MFN-125-80

SUBJECT: MARK I CONTAINMENT PROGRAM
ADDITIONAL INFORMATION ON VENT SYSTEM COMPRESSIBILITY
EFFECTS ON MARK I POOL SWELL

RESPONSE TO NRC QUESTIONS ON NEDE-24778-P,

Vent System Compressibility-Effects on Mark I Pool Swell

Figure 1. Full Scale Vent (from Reference 1)

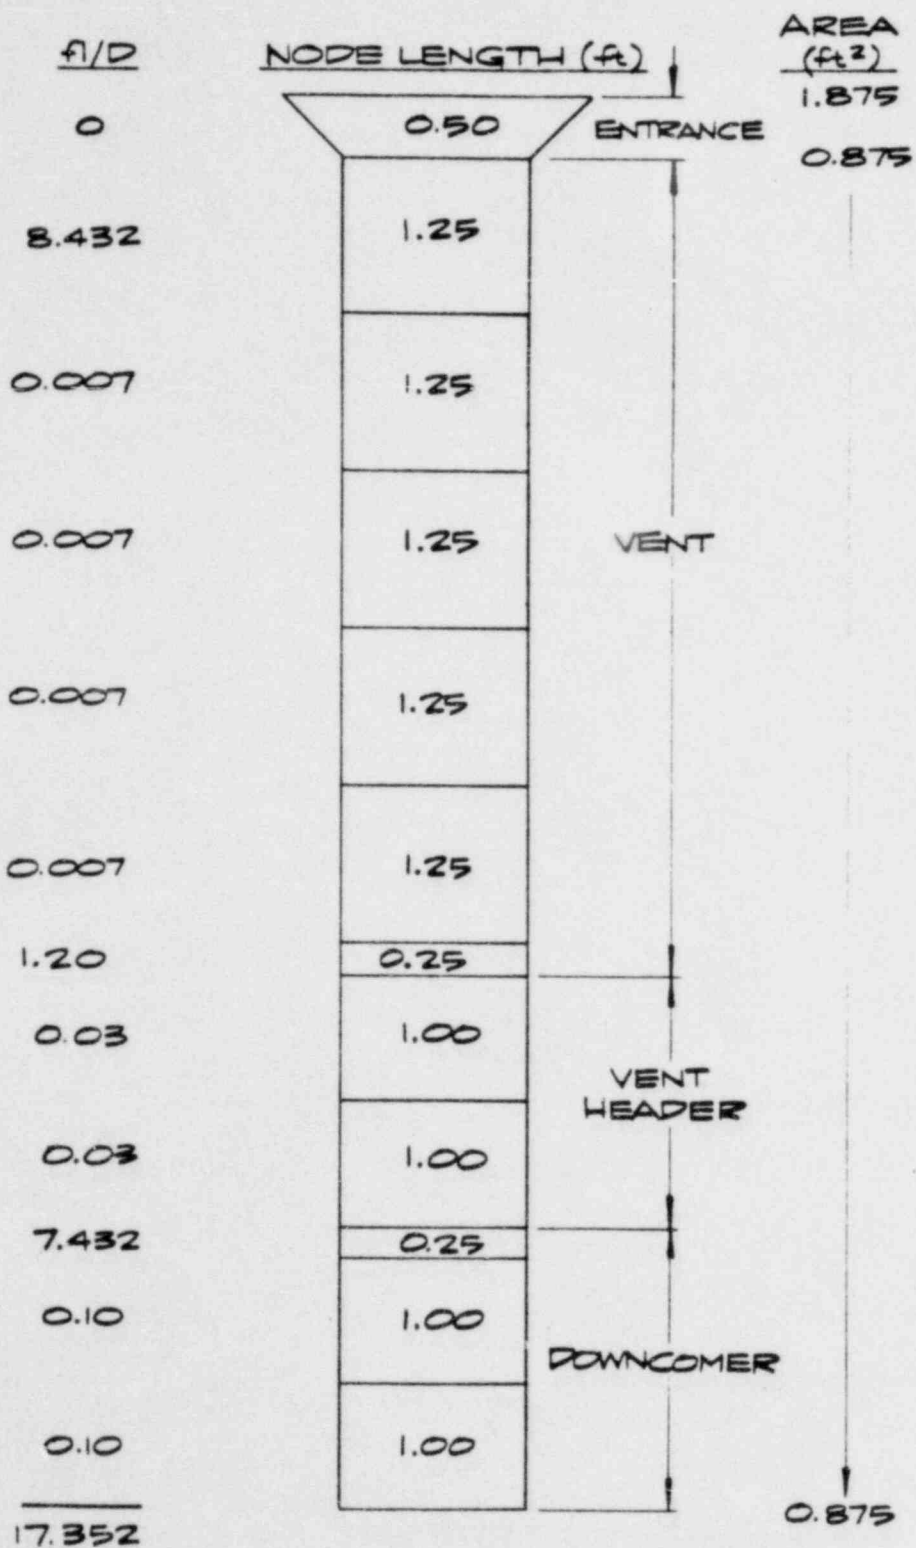
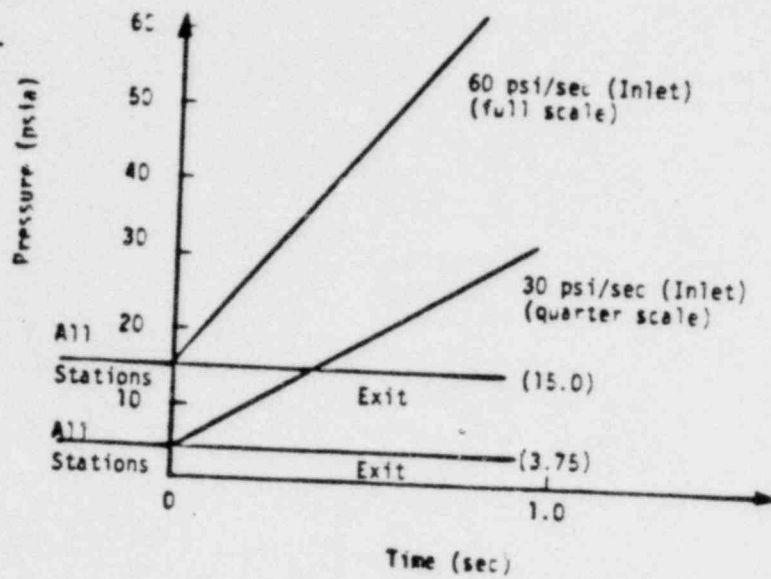
At the April 23 meeting a question was raised concerning the appropriate way to treat the dump loss when scaling total vent system resistance $F1/D$. The analysis in Appendix A confirms that the dump loss should be included when scaling the $F1/D$ (which was the approach taken for the QSTF tests),

Thus scaling vent entrance stagnation and exit static pressures by λ and requiring that $U_e \sim \lambda^{1/2}$ leads to (9), i.e., the dump loss = 1.0 is added to the prototype duct loss coefficient before scaling and the sum scales to $(K+1)_M$.

Figure 4. Compressibility study case A.

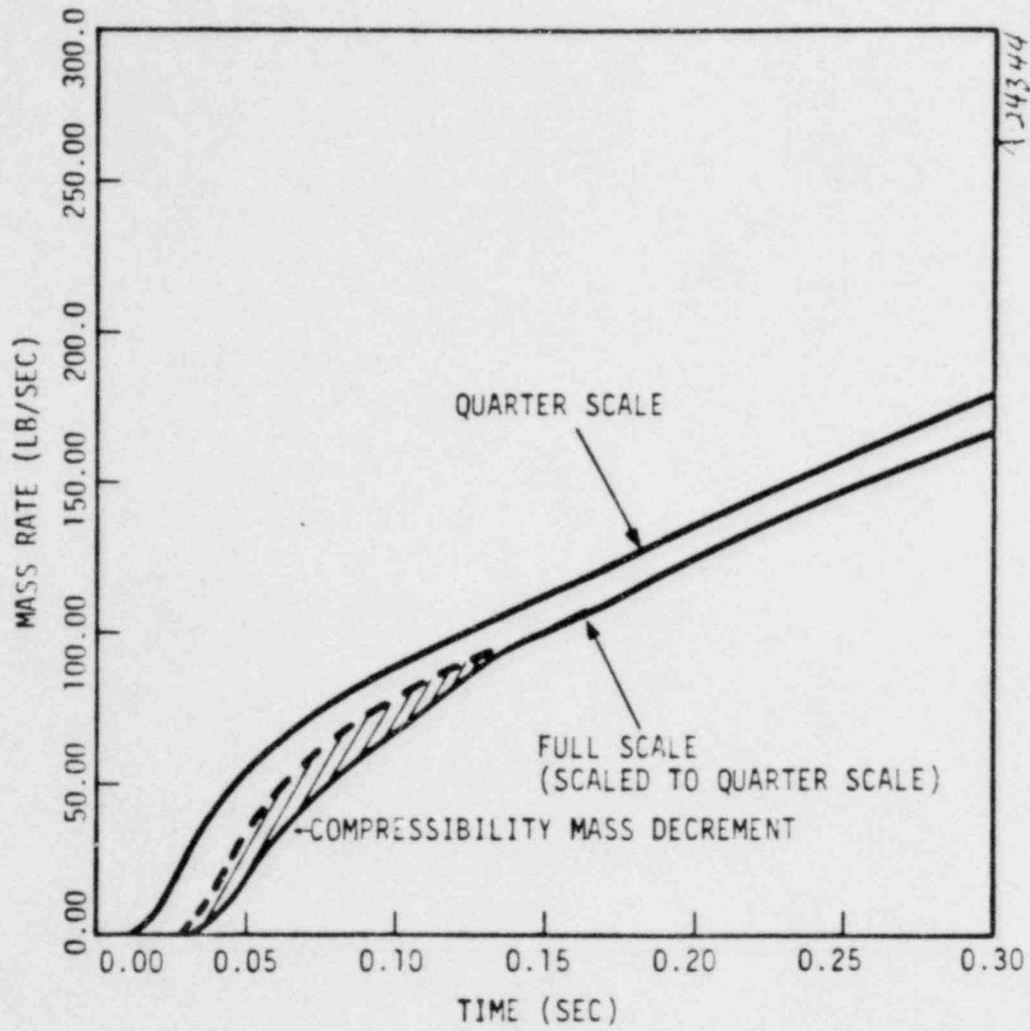
A small mass defect is observable in Case 1 and no net effect can be seen in Case 3. These results, which indicate essentially no net mass defect for the pressure ramp type boundary condition, are in conflict with the previously reported results shown in Figure 4. Explanation for this difference probably lie in some combination of the following considerations: 1) more prototypical nodal system; 2) scale factor = .28 rather than .25; and 3) "qualitative" nature of the shaded region in Figure 4.

Figure 6. Full scale vent system -- 26-node configuration.

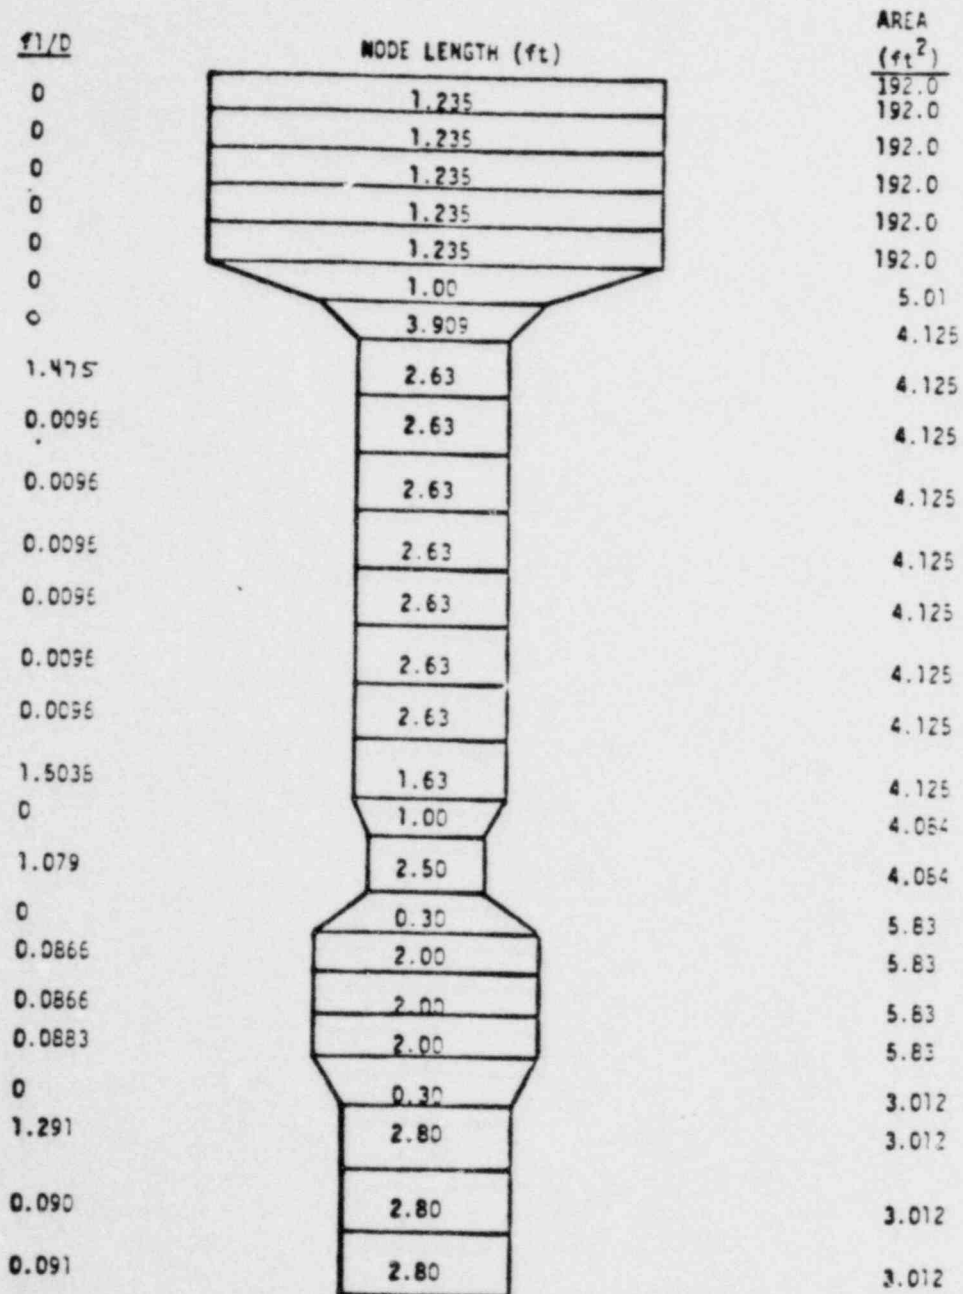
The requested additional analyses used a more prototypical nodal system shown in Figures 6, 7, 7A. Vent area changes and a drywell were included. The "quarter scale" vent models were run at a scale factor of .2801 since the full scale nodal system was for Monticello and $\lambda = .2801$ was the QSTF scale factor for Monticello. The additional F1/D required for Moody scaling was added to the subscale model in two fashions: a) by directly ratioing each nodal loss (distributed); b) by adding the additional resistance in two nodes approximately where the QSTF orifices were placed (lumped). Note that the additional F1/D when added at an area different than the exit (reference) area was ratioed by $\left(\frac{A_{local}}{A_{exit}}\right)^2$. Again, the dump loss was included in the scaling as discussed in Appendix A.

FIGURE 13. DRYWELL PRESSURE CASE 3- CONSTANT \dot{m} INTO DRYWELL DISTRIBUTED LOSSES IN SUBSCALE

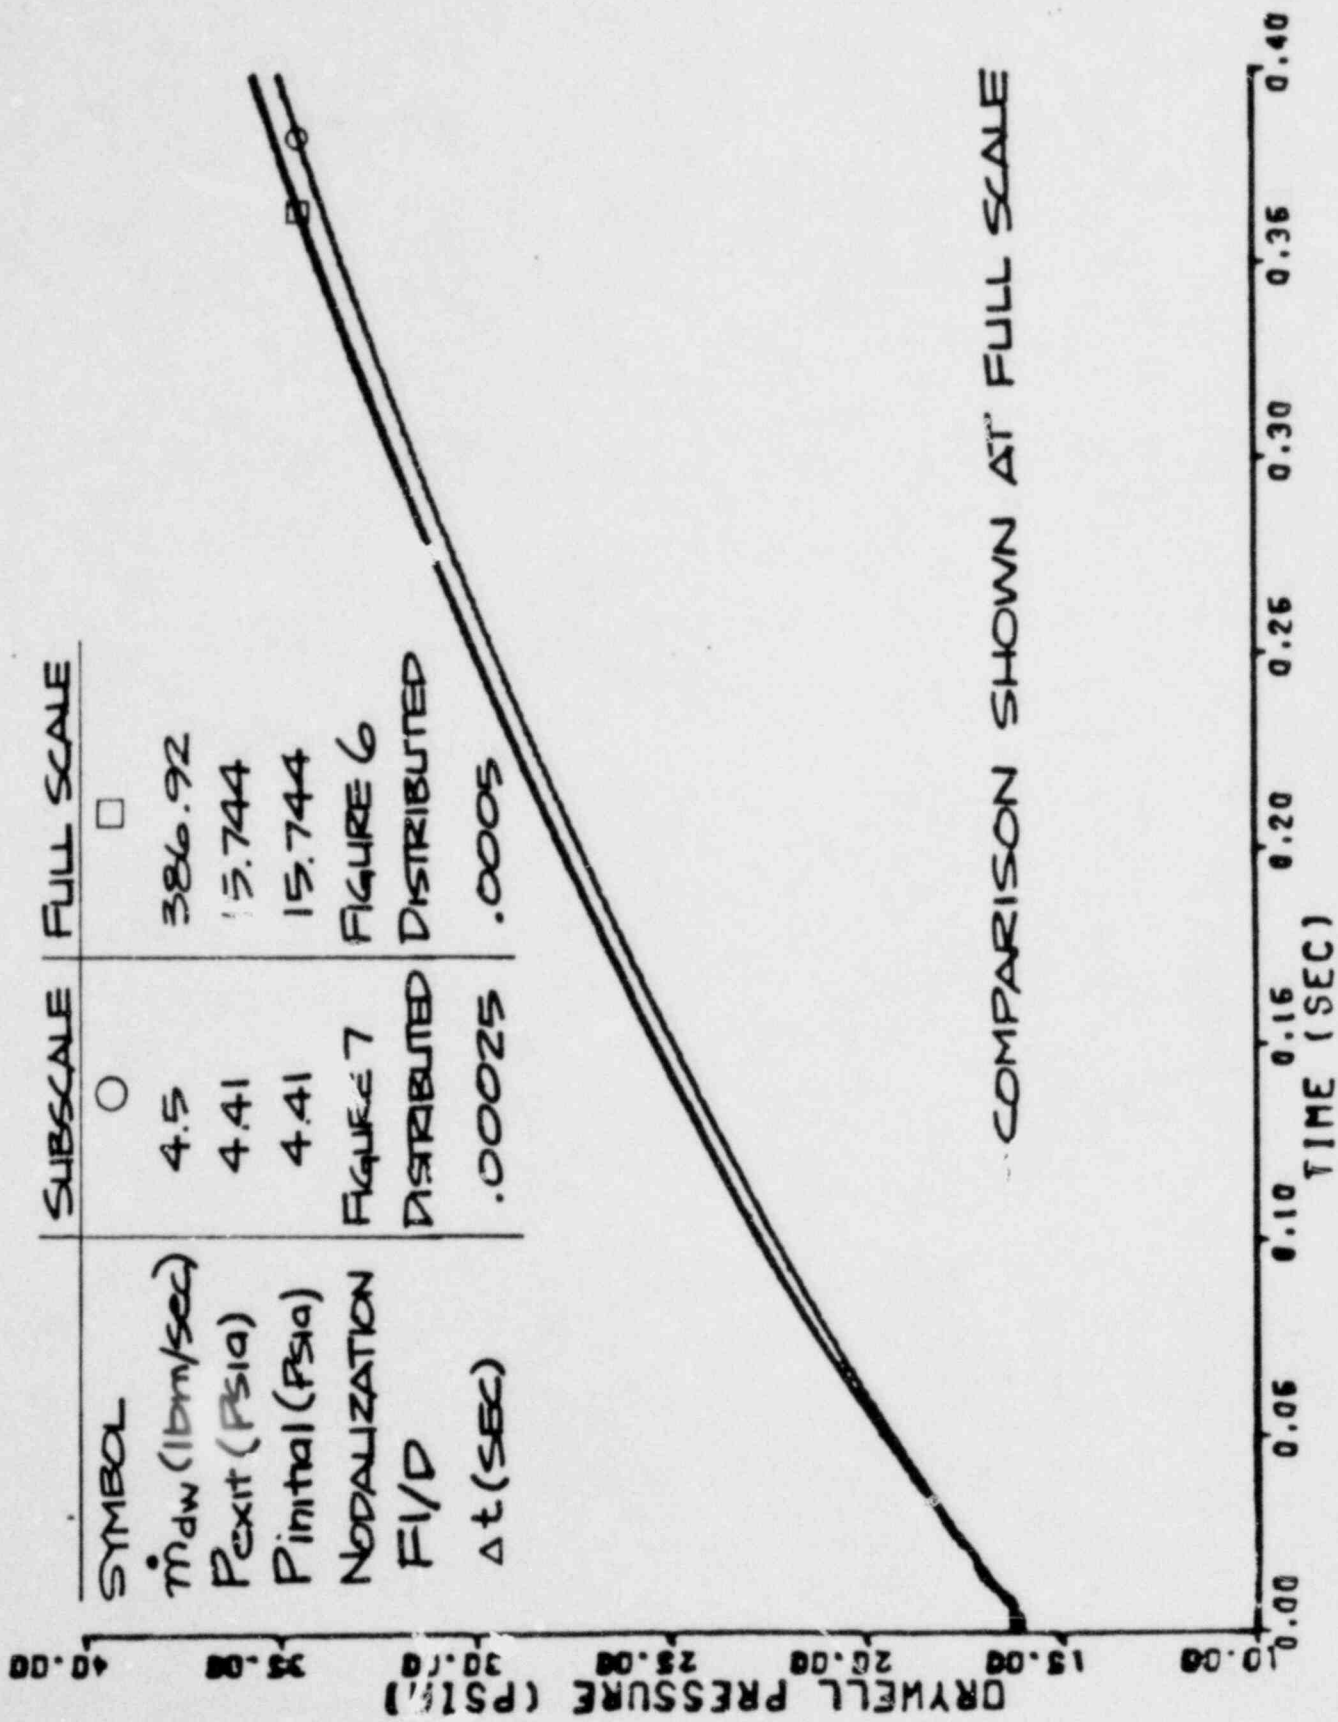
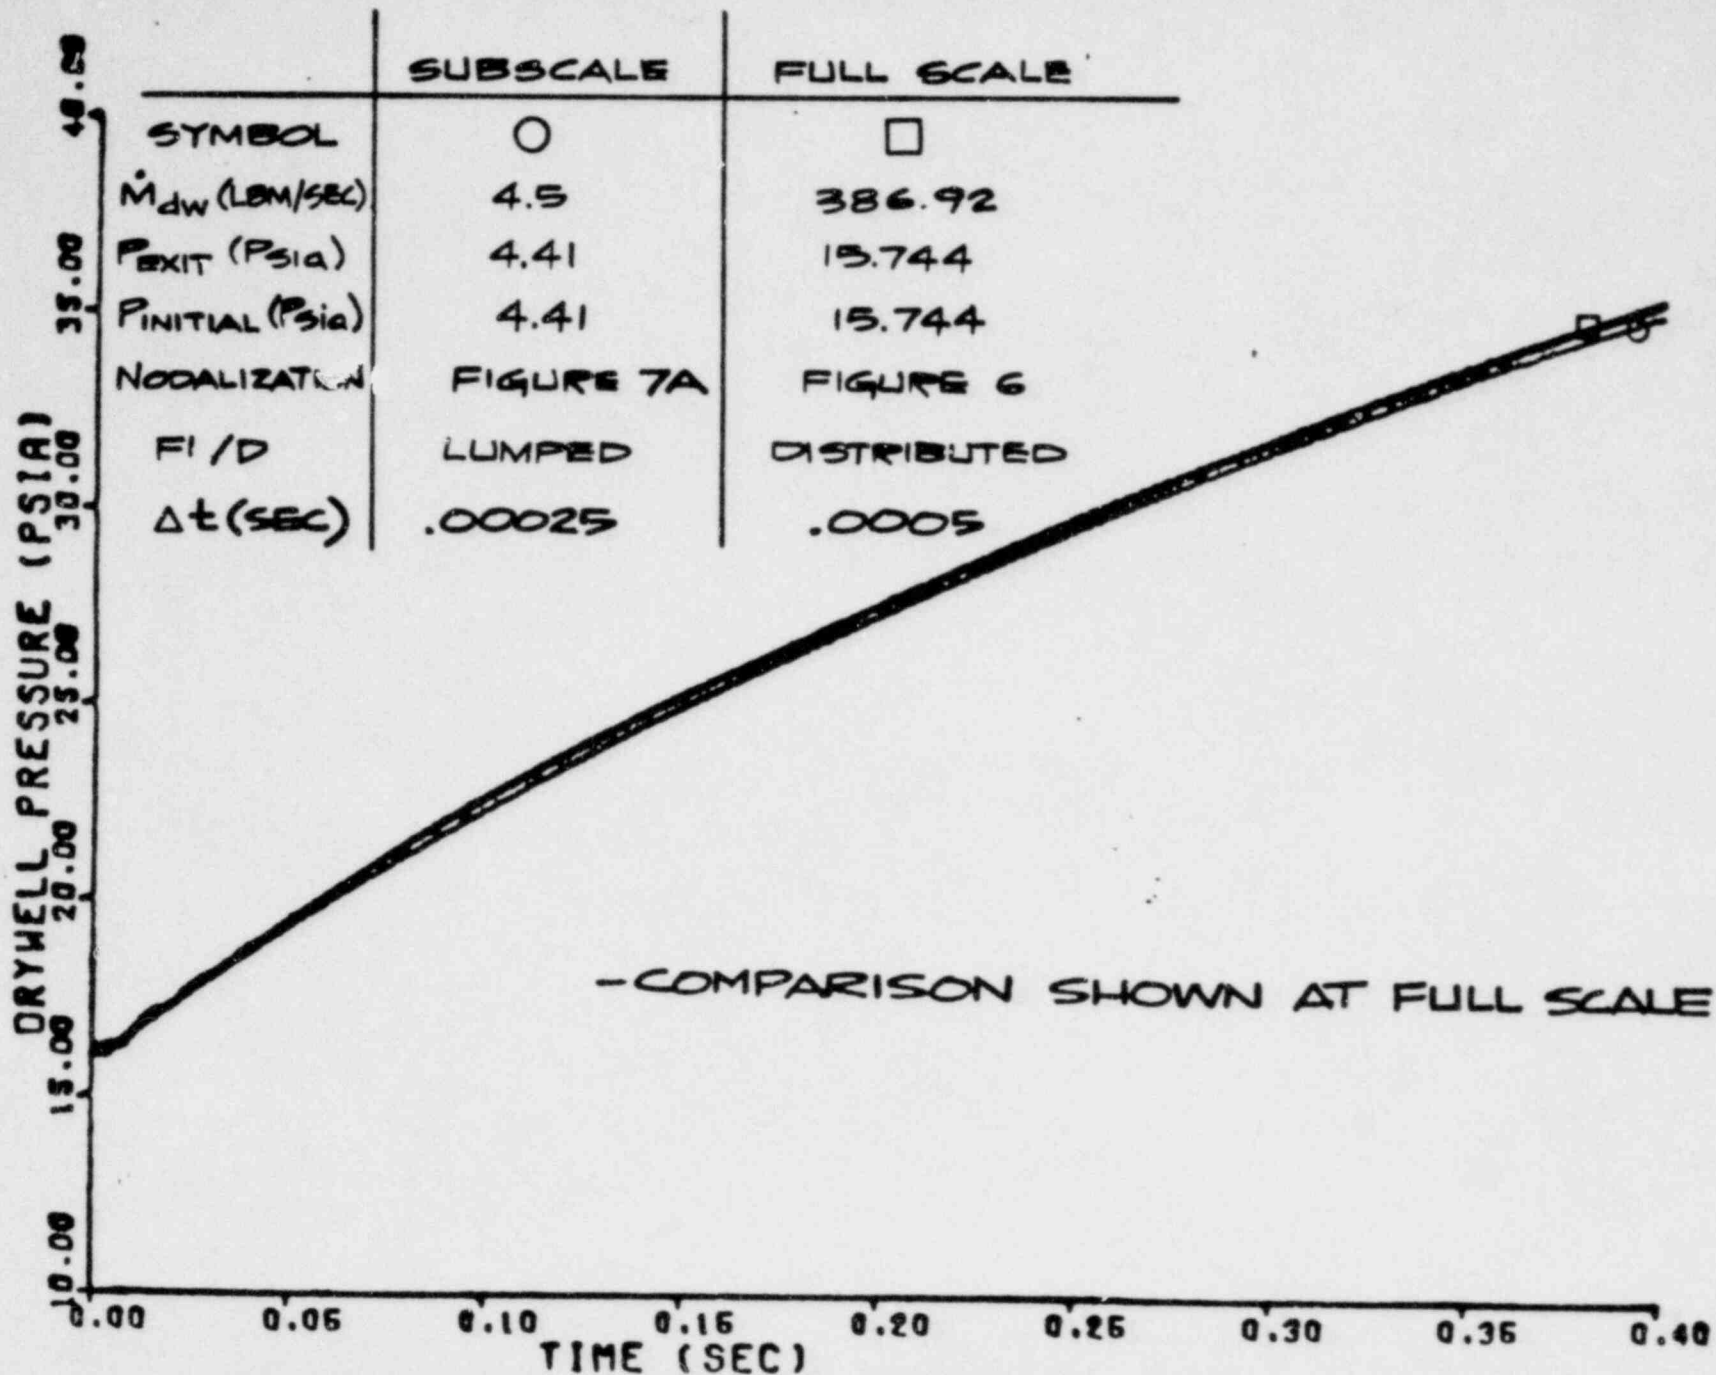
Results for Case 1, a 60 psi/sec full scale ramp and Case 3, a constant mass rate = 386.92 lbm/sec into the drywell, are shown in Figures 9 through 12. Drywell pressure histories for Case 3 are shown in Figures 13 and 14. Note that the QSTF type resistance placement resulted in better simulation of the drywell pressure transients than the ratioed F1/D configuration due to a slightly larger effective drywell capacitance for the distributed case. Results for Case 3 using the QSTF type F1/D distribution (Figures 12 and 14) are considered more representative since similar drywell histories resulted.
